**Planning Commission**  
**CITY HALL COUNCIL CHAMBERS**  
**AGENDA OF MARCH 10, 2026**  
**7:00 PM**

**NORTH RIDGEVILLE PLANNING COMMISSION  
MINUTES OF REGULAR MEETING  
TUESDAY, FEBRUARY 10, 2026**

## Planning Review

## Planning Commission Comment Sheet

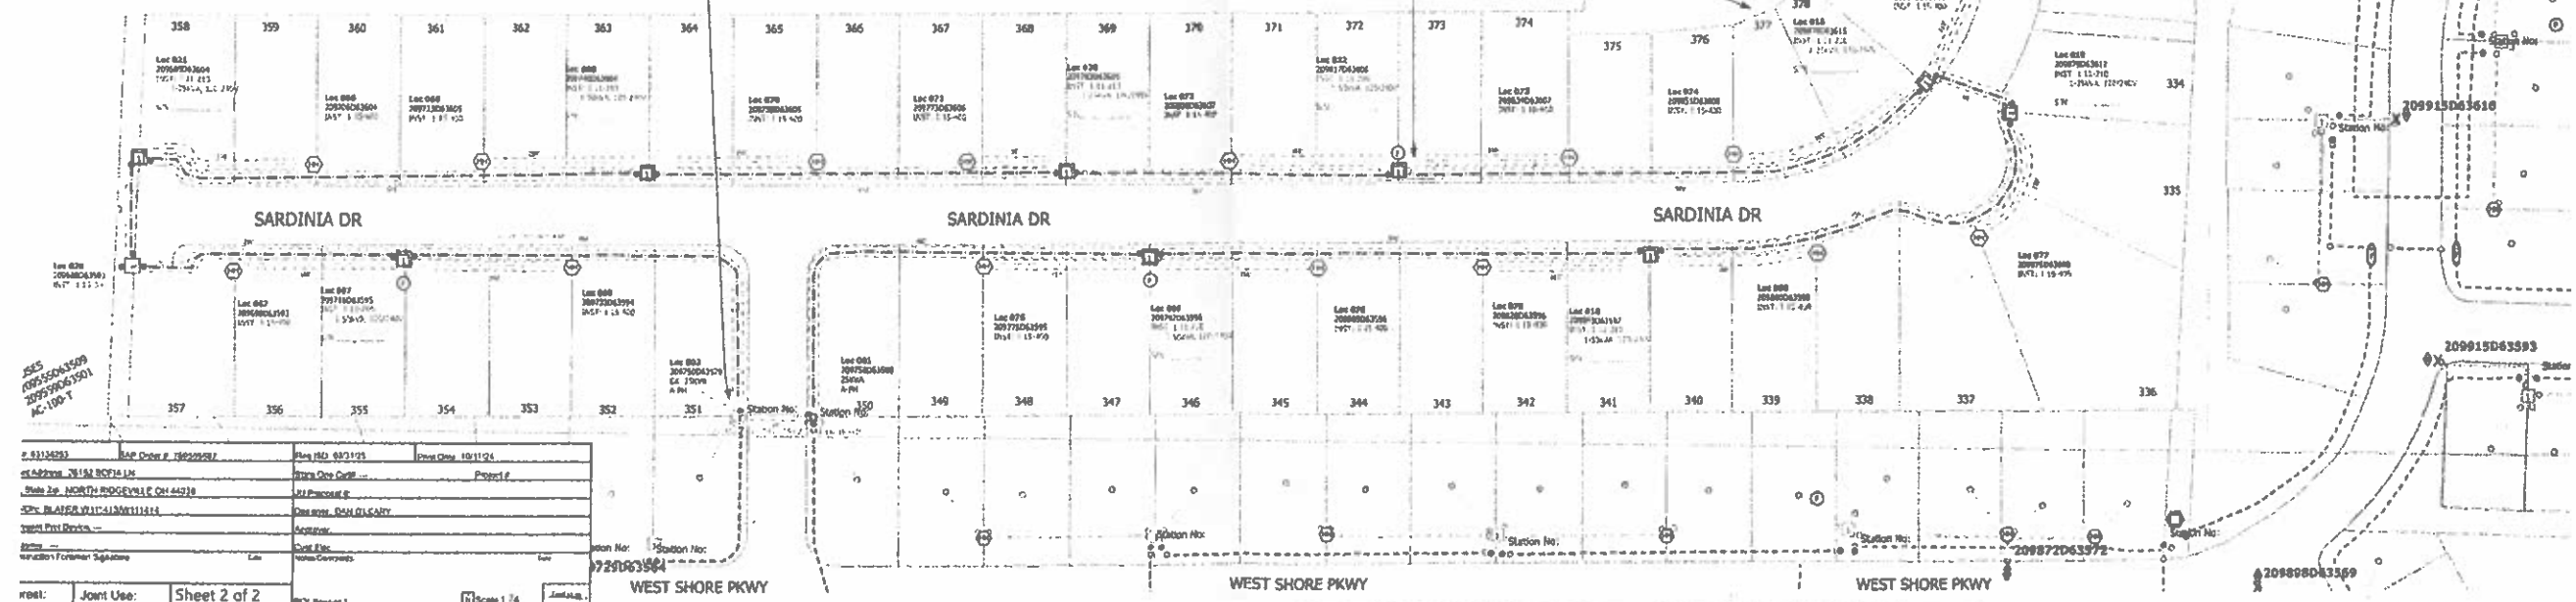
- 3ft buffer to be maintained near Driveways, Manholes and valves

- 2ft offset Min. from any water or sewer line.

- 3 • Do not place any Handhole or Junction Box in an easement Access area

- S/L numbers Do not Match ph9 Approved plan Set
